Fire Station 6

Fire Station 6 is a single-level structure (basement for storage only) located in East Duluth. The historic building was remodeled and an accessible toilet room was provided in the lobby area. The remodeling did not provide features of accessibility in the kitchen or locker rooms. An exterior ramp was added to the main entry, however the slope currently exceeds the maximum allowed of 8.33% (at 12.2%).

Accessibility Review

Photo 2: Add handrails at the ramp in the garage area. (Currently a guardrail on the open side.)

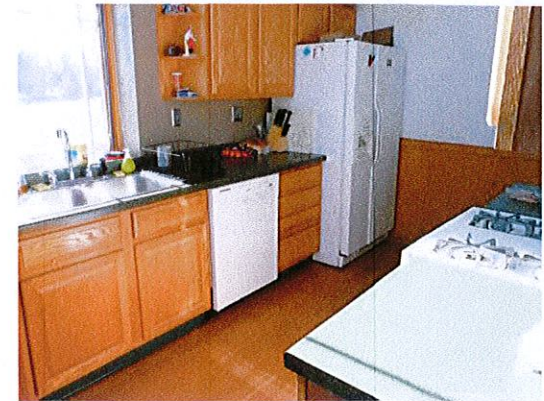
Location JQP # / Item #	Solution / Comments	Qty	Unit Cost	Total Cost	Priority	Estimated Compl. Date	Person Responsible	Actual Compl. Date	Actual Cost
Apparatus Area									
15A 15819	Provide fully compliant handrails on both sides of the sloped surface. ICC ANSI 405.8 <i>There is not currently a handrail on the wall side. The open side currently has a guardrail at 46" AFF. Photo 2.</i>	40	\$25	\$1,000	3				
Locker Room									
22B 15814	Install signage with appropriate raised and Braille lettering. MN 1341 1110.2	1	\$40	\$40	3				
Parking									
05A 15821	Stripe an appropriate number of accessible parking stalls and provide appropriate permanent signage. IBC 1106.1 <i>There is room for 9 vehicles in the lot. Currently none have been designated as accessible. The route from the parking lot is stairs to a secure entry or around the building via the city sidewalk.</i>	1	\$400	\$400	3				
Single User Toilet Room- Lobby
